REMARKS

Applicant understands that agreement has been reached between the Examiner and Applicant's prior counsel that the claims, as amended July 21, 2004, patentably distinguish over the prior art of record. The purpose of this Second Supplemental Amendment is to correct obvious errors in the specification and claims, and to add new claims that do not include means-plus-function limitations.

IN THE DRAWINGS

**FIG 5**

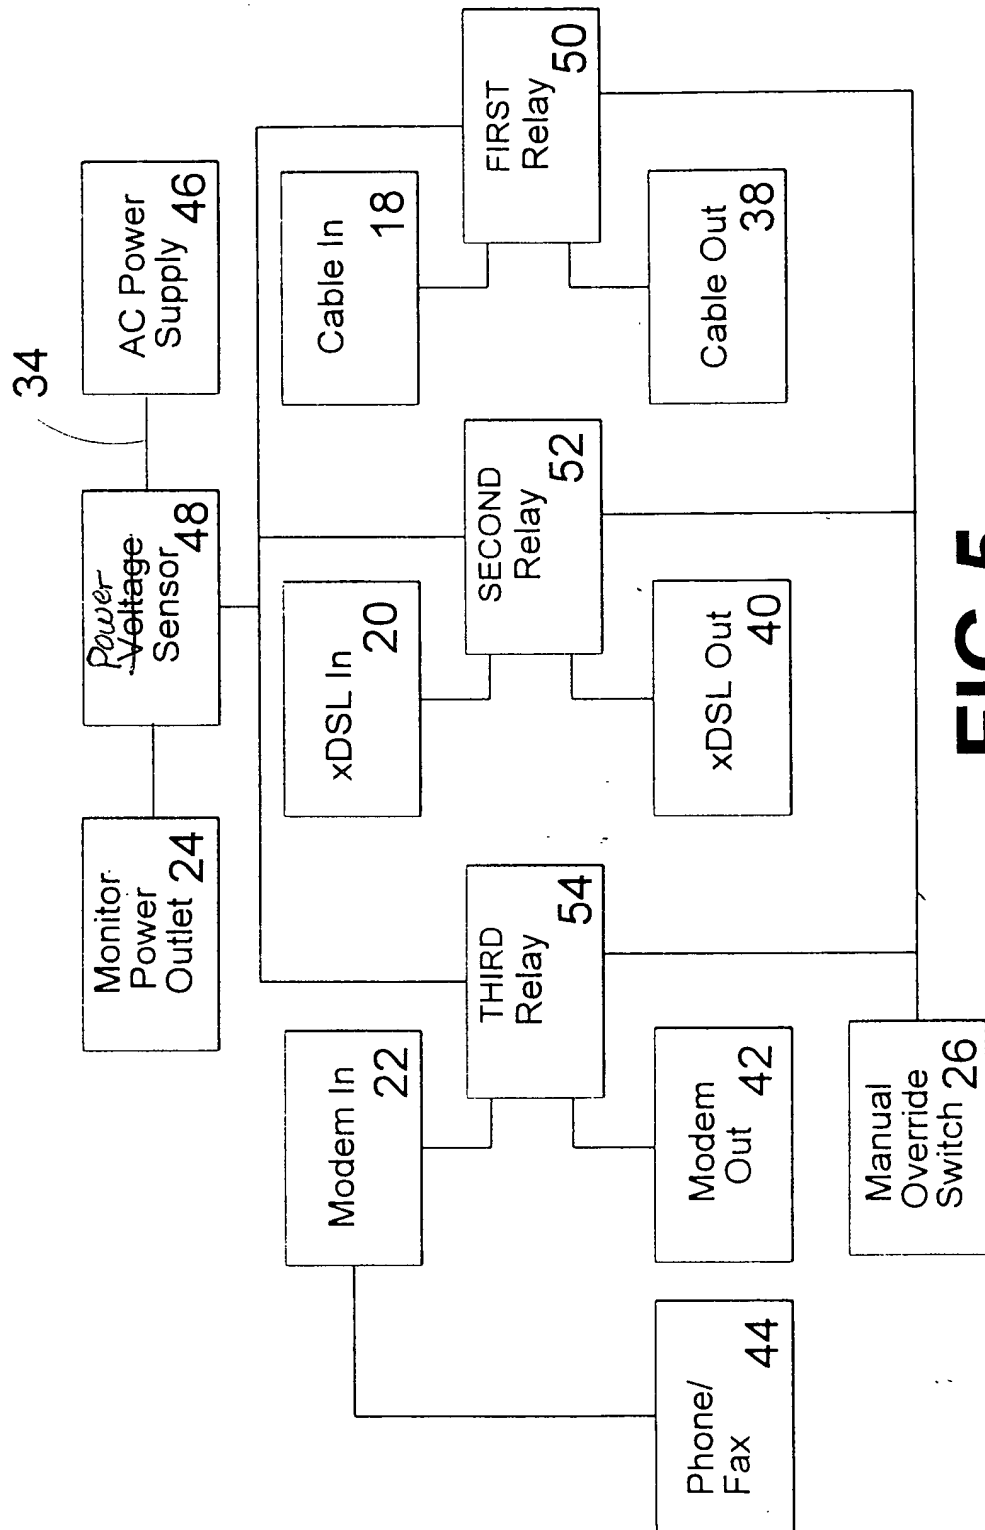
Figs. 5 and 6 are amended as shown in the attached replacement sheets. In Fig. 5, the label “Voltage Sensor” in item 48 is changed to “Power Sensor,” for reasons that will be discussed below in greater detail.

The use of the term voltage, with respect to sensor 48, throughout the specification is potentially confusing. In particular, electrical power is the product of the voltage and the current. Thus, power sensors typically include a voltage sensor, a current sensor, or both. However, in Fig. 5, voltage sensor 48 is shown coupled directly to AC power supply 46, which may give the incorrect impression that voltage sensor 48 is monitoring the voltage provided by AC power supply 46 (e.g., a wall outlet). Of course, the amount of power drawn by the monitor should not affect the voltage provided by AC power supply 46, unless the monitor tries to draw more current than the supply 46 can provide.

Changing the term “voltage” to “power” clarifies the specification, because the level of power drawn by the computer/monitor is what triggers the relay, regardless of whether the power consumption is determined by measuring voltage or current. Further, it is clear from Applicant’s original disclosure that this is the case. Note for example, in original Fig. 5, “AC Power Sensor 48.” Also, note Applicant’s original disclosure at Page 19, Lines 8-10, which provides: “In operation, the personal computer failsafe protection device 10 is connected to a monitor of a computer system or to a one piece computer system 56 **for measuring the amount of power being drawn thereby**” (emphasis added). Further, at Page 16, Lines 18-19, Applicant’s original disclosure provides: “A block diagram of the personal computer failsafe protection device 10 used **to sense the power usage of a monitor** is shown in Figure 5” (emphasis added). Thus, there is clear support in Applicant’s original disclosure for the clarifying amendments made herein.

Please amend Fig.5 and Fig. 6 by substituting the attached replacement sheets 5 of 6 (Fig. 5) and 6 of 6 (Fig. 6) for the originally filed sheets 5 and 6 of the drawings.
